## PRODUCT/PROCESS CHANGE NOTICE (PCN)

PCN #: **A-0412-04**                      DATE: 12/15/2004

Product Affected: All Green Products

### ATTACHMENT - PCN #: A-0412-04

#### Attachment 1: (IDT standard bar code label)

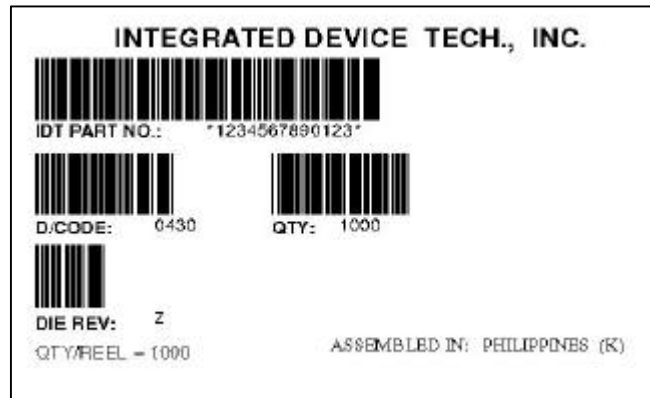
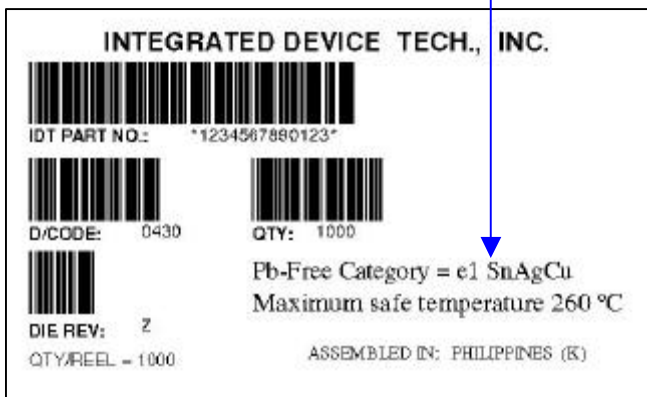
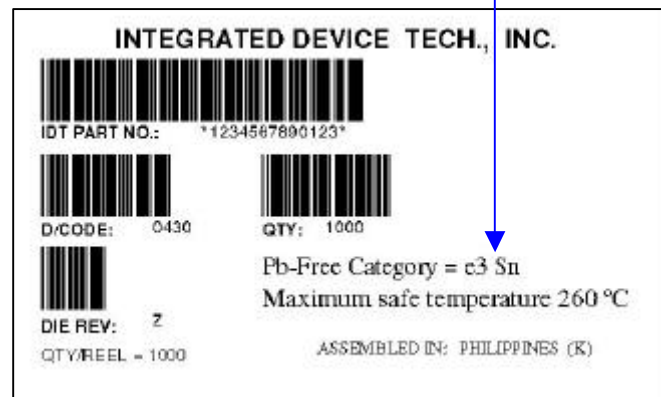
Add Pb-free words, category and maximum safe operating temperature to IDT standard bar code label.

Pb-free category = e1 SnAgCu (BGA packages)  
and maximum safe temperature

Pb-free category = e3 Sn (lead frame packages)  
and maximum safe temperature

#### Attachment 2: (Customer specific)

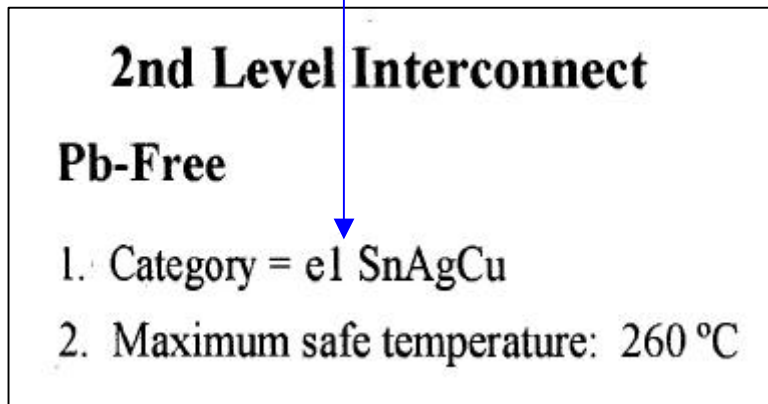
Add an additional 2nd Level Interconnect label consisting of Pb-free words, category and maximum safe operating temperature.

Category = e1 SnAgCu (BGA packages)

Category = e3 Sn (lead frame packages)
